Forsyth County Procurement

ADDENDUM #4

RFP 20-78-1620

For: Providing all labor, equipment and materials for the construction of a new Juvenile Justice Center at 875 Lanier 400 Parkway, Cumming, GA 30040. Project includes a multi-phased site development, demolition of existing motel structures and construction of new 62,000 square foot Juvenile Court building.

Sheet No.: **A-4.01**
RELEASED FOR CONSTRUCTION

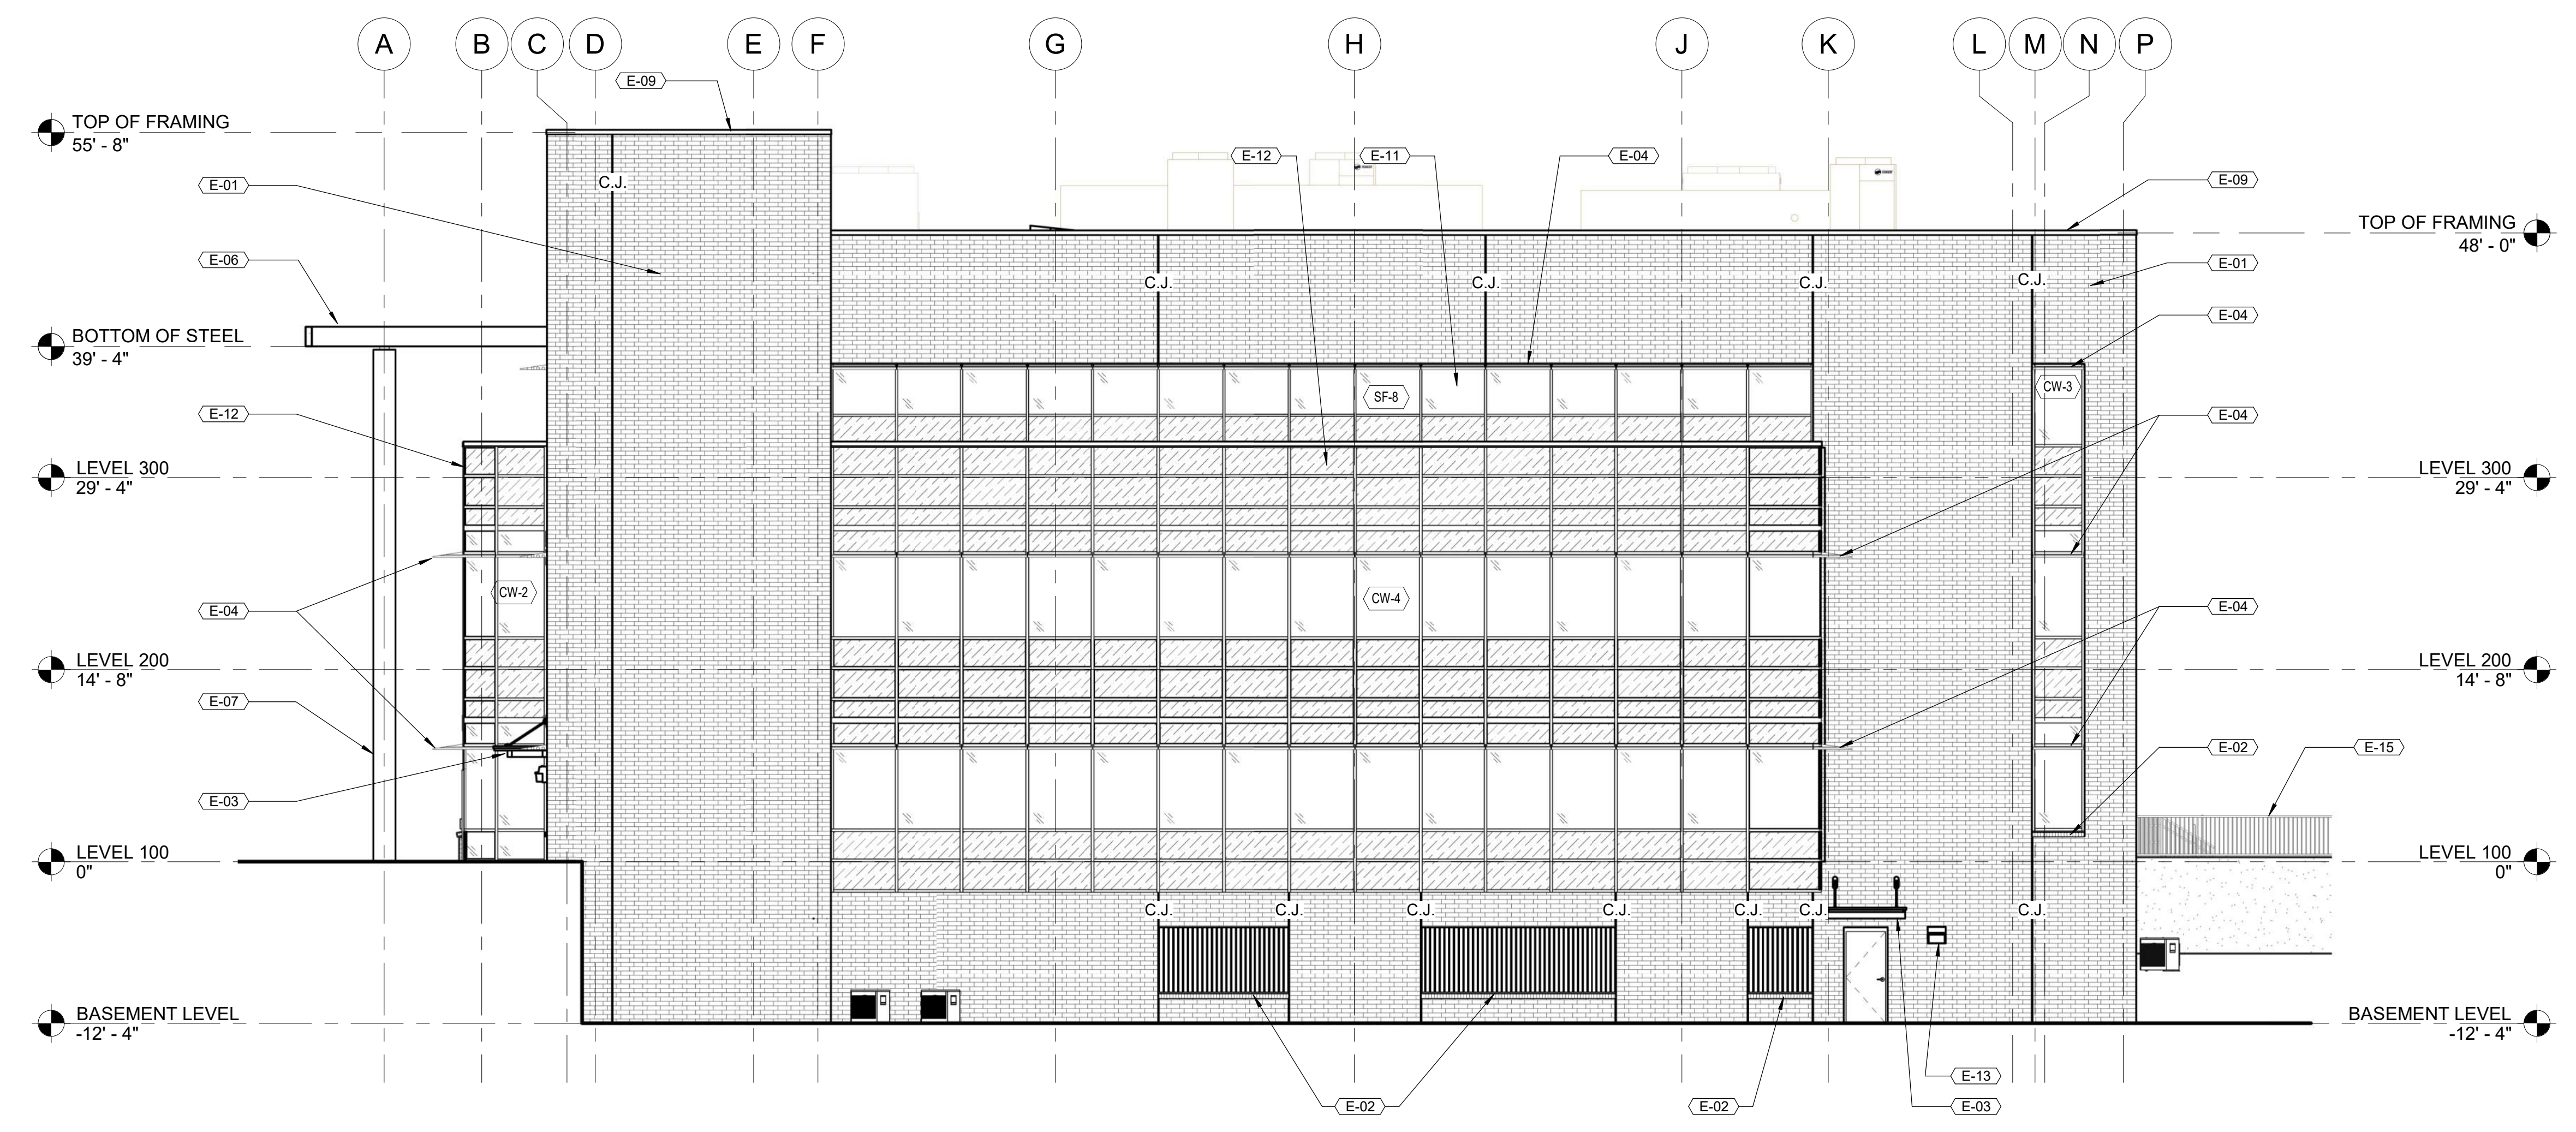
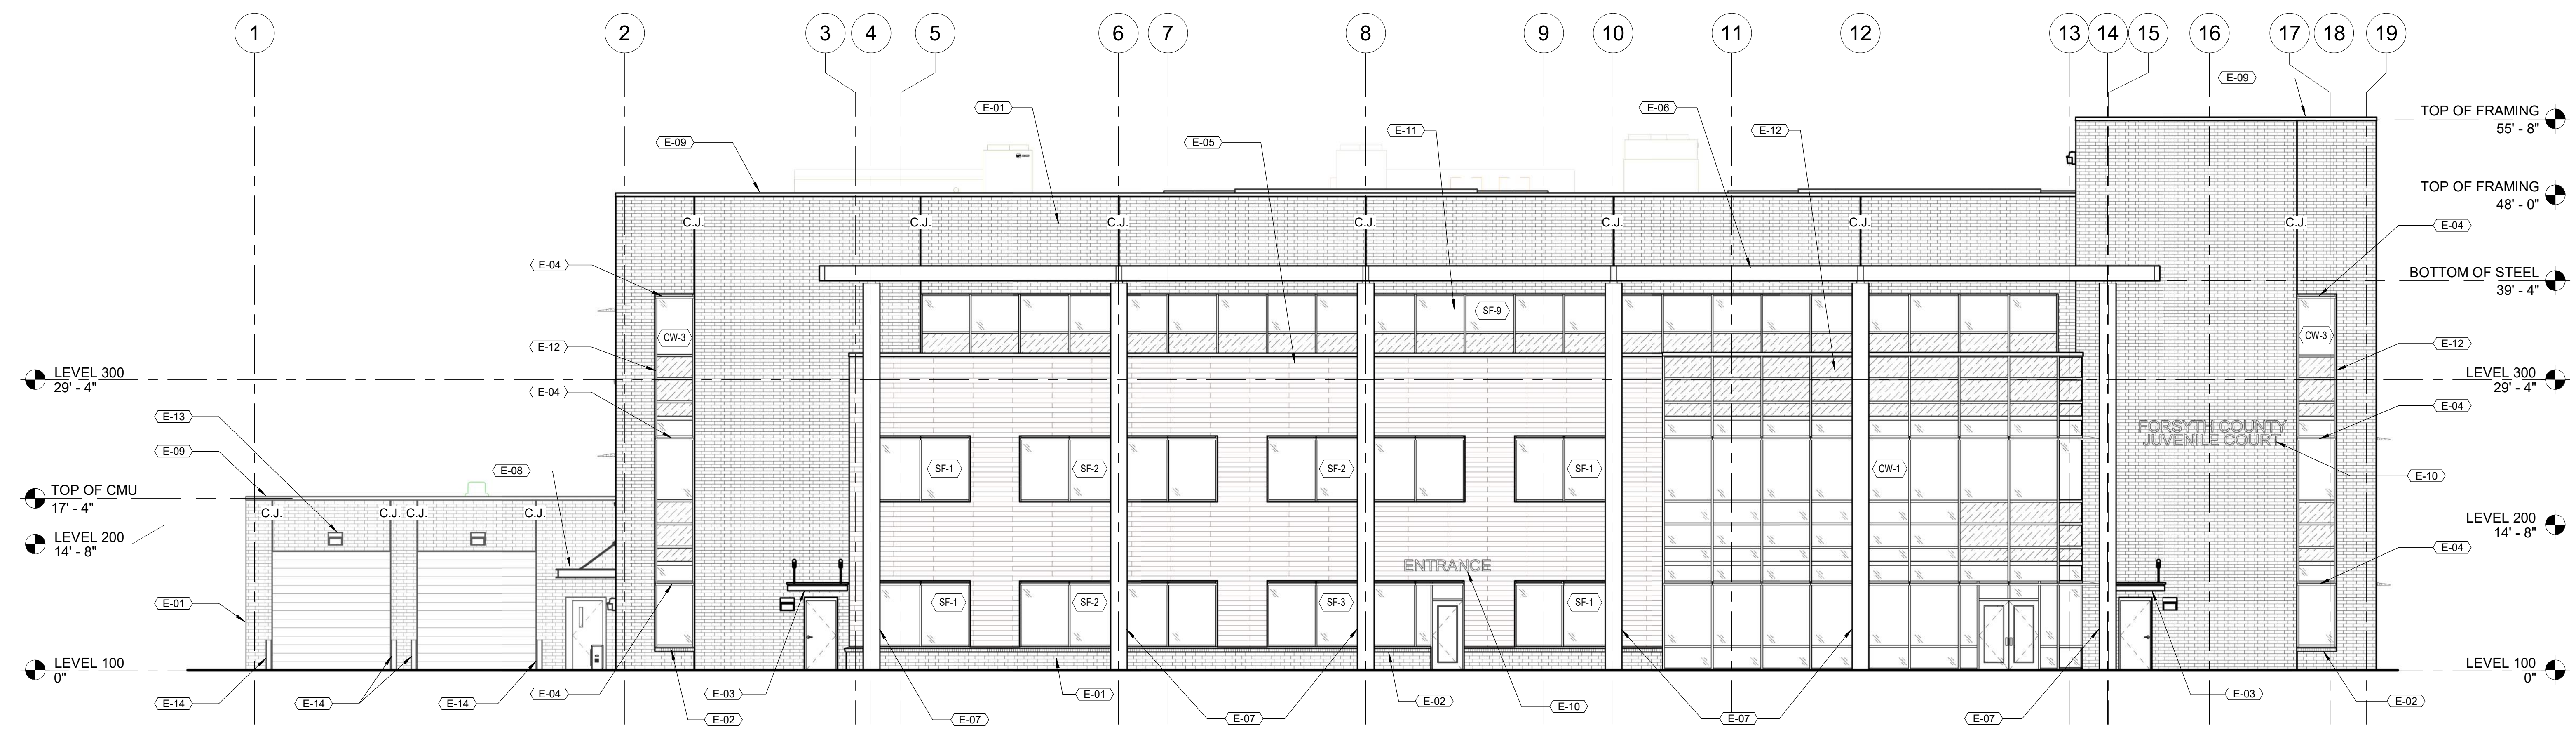
- a. **RESPONSE: *This is a RFP and schedule is one of the items to be included in the submitted proposal.***
2. REFERENCE SHEETS A4.01 and A4.02: Please advise what the Keynote #E-11 is.

2-4 Sheet A-4.01 EXTERIOR ELEVATIONS:

1. Added description for keynote E-11.
2. Reference sheet A-4.01 EXTERIOR ELEVATIONS revised under addendum #04 dated 07/07/2020.

- a. **RESPONSE: *Keynote #E-11 refers to Storefront System. Sheets will be revised for Addendum #4.***
3. REFERENCE SHEETS A4.02: Please advise on the CW-xx designation of the curtainwall (Keynote #E-12) at column line 19 of the North Elevation.

Sheet No.:
A-4.02
 RELEASED FOR CONSTRUCTION

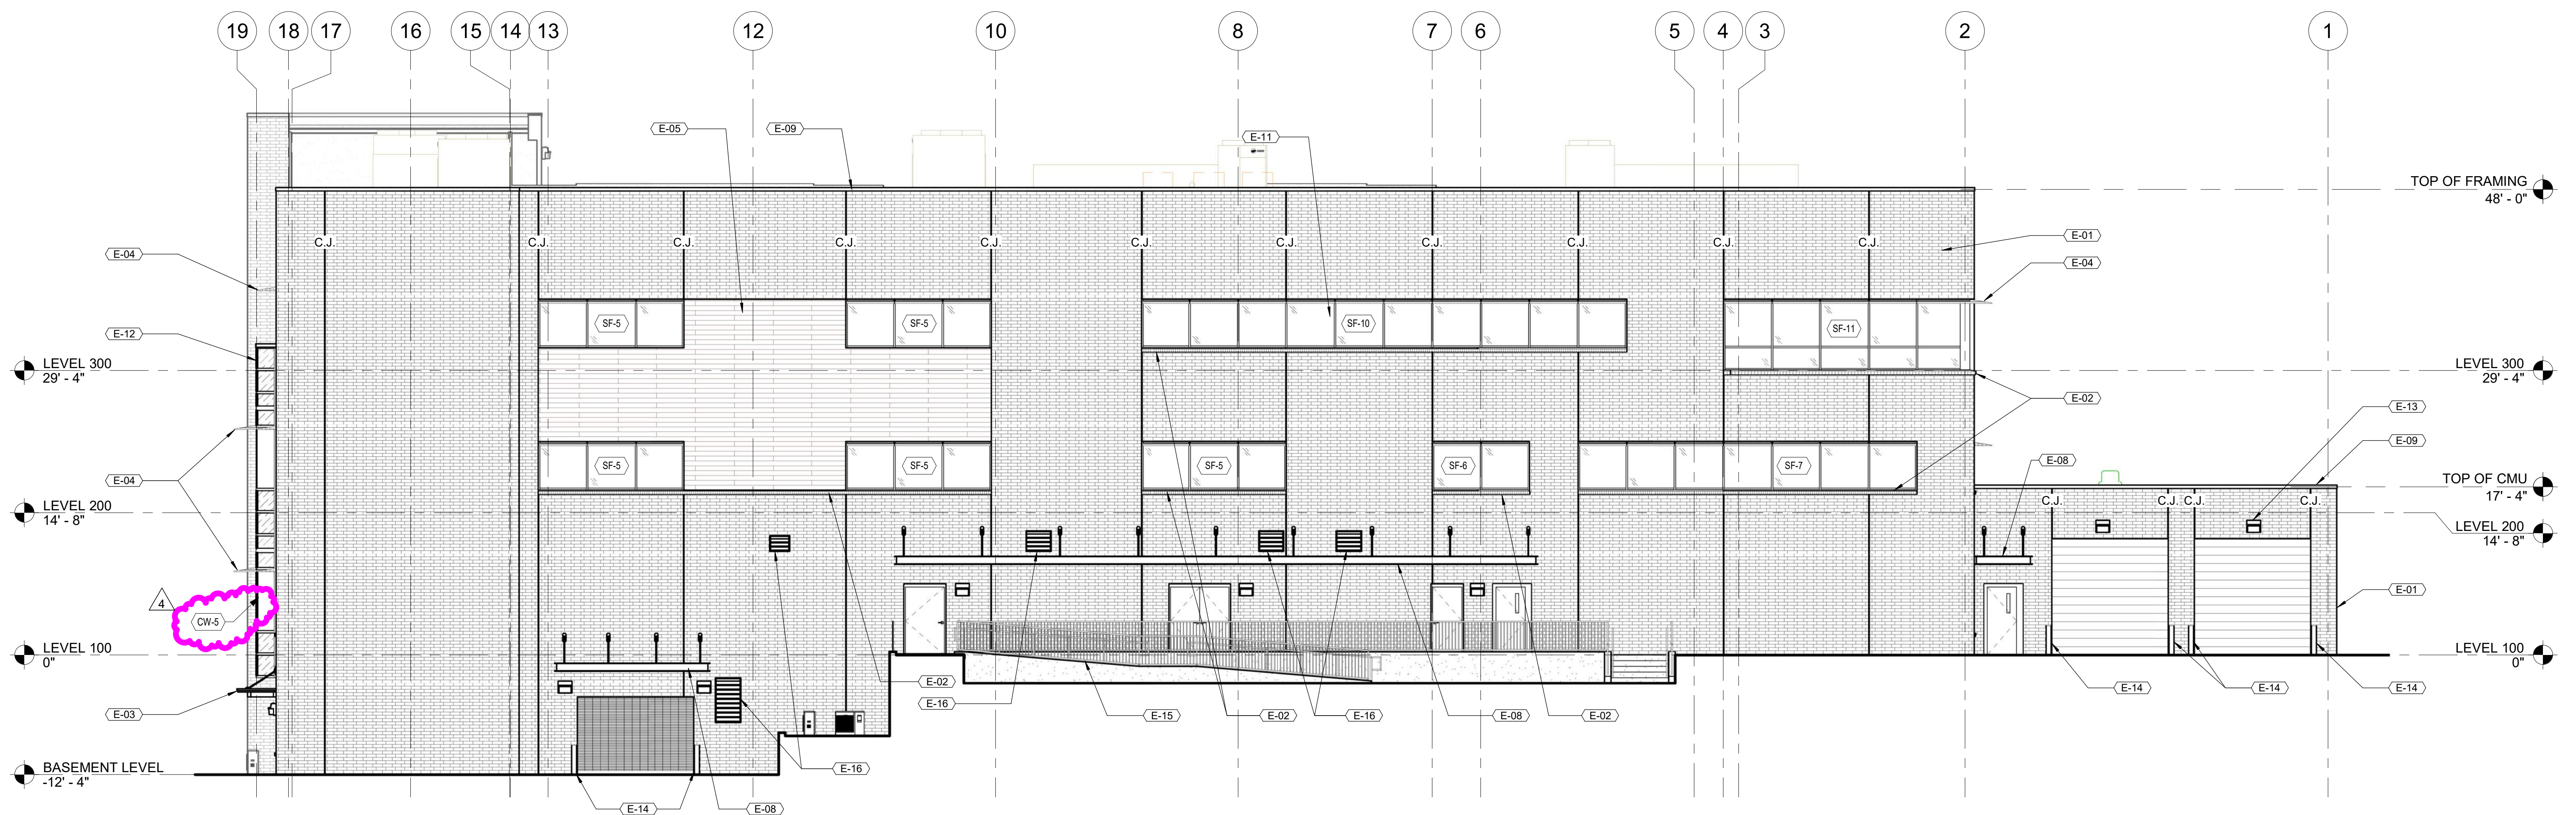
2-5 Sheet A-4.02 EXTERIOR ELEVATIONS:

1. Added description for keynote E-11.
2. Noted location of curtainwall type CW-5.
3. Reference sheet A-4.02 EXTERIOR ELEVATIONS revised under addendum #04 dated 07/07/2020.

- a. **RESPONSE: *CW-5 is the curtainwall system in question, is not tagged in the elevation.***
4. Item #4 on Addendum #2 states that building permit fees are by the Contractor. Is the building permit expected to be ready when the project is awarded?

Sheet No.
M-1.03
RELEASED FOR CONSTRUCTION

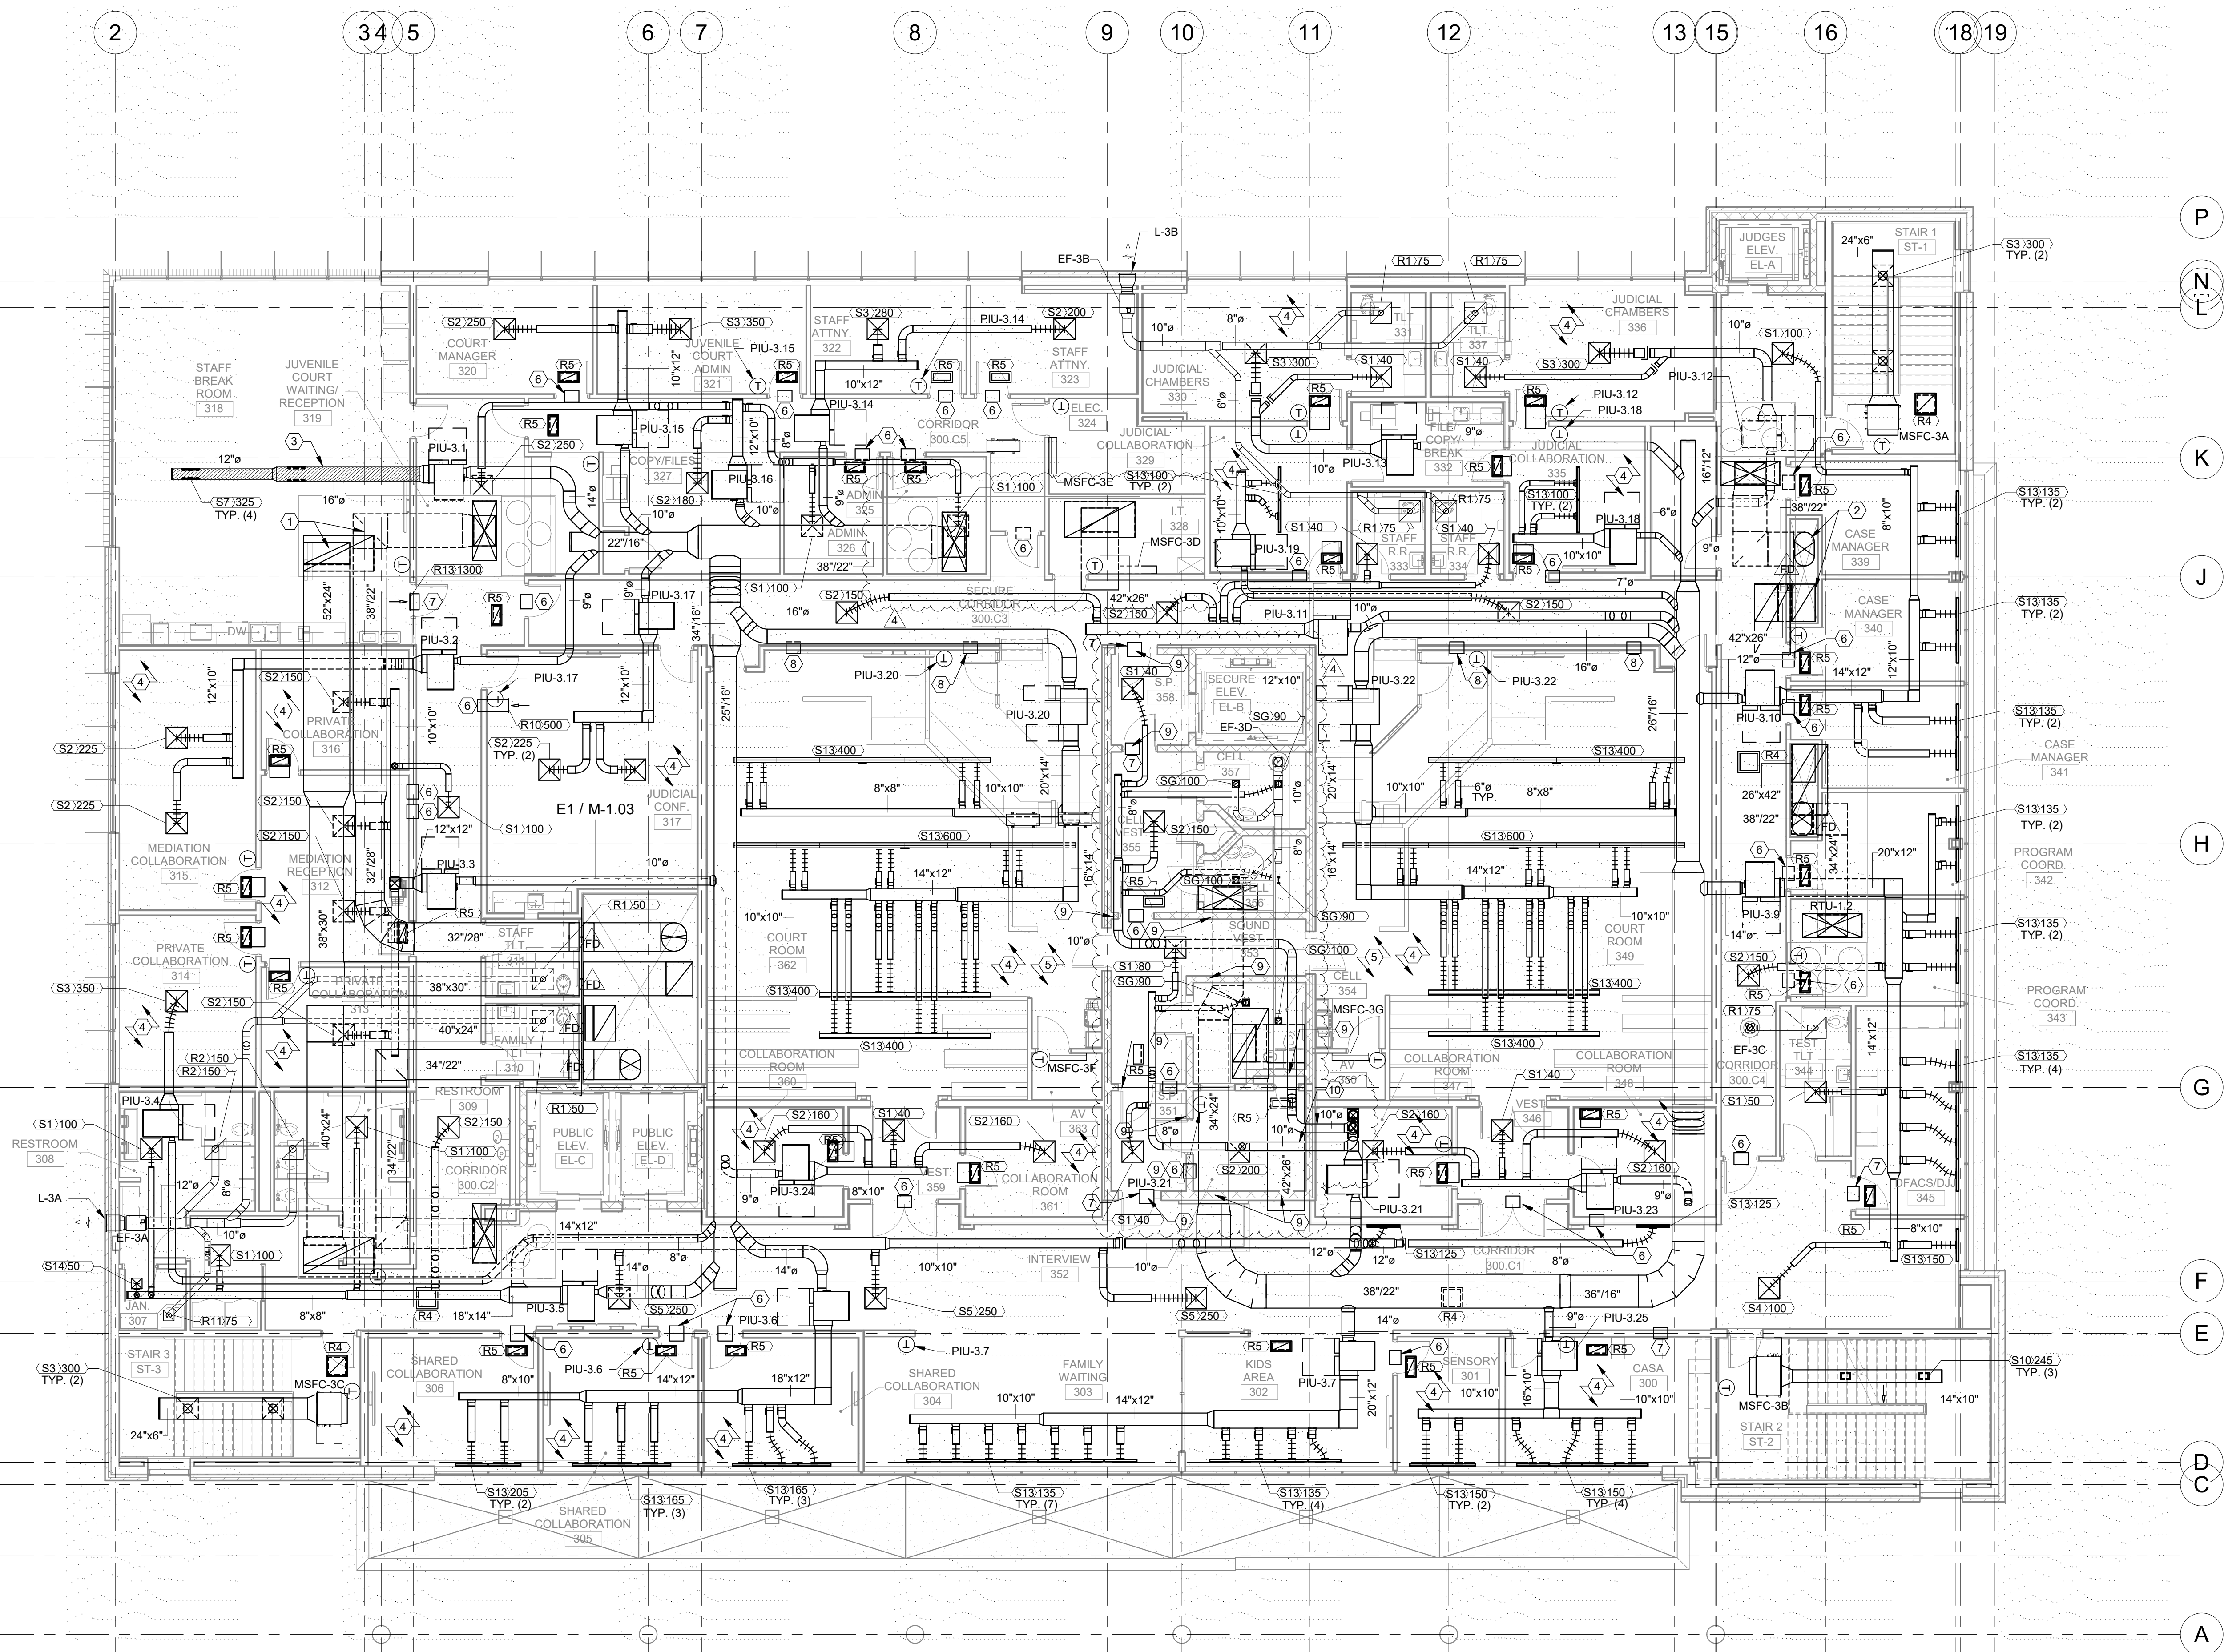
2-8 Sheet M-1.03 LEVEL 300 FLOOR PLAN - MECHANICAL:

1. Adjusted RTU-2.1 and RTU 3.2 location.

2. Adjusted ductwork in secure areas under RTU-3.2. Added keynote to address ductwork routing in structural webbing.
3. Reference sheet M-1.03 LEVEL 300 FLOOR PLAN - MECHANICAL revised under addendum #04 dated 07/07/2020.
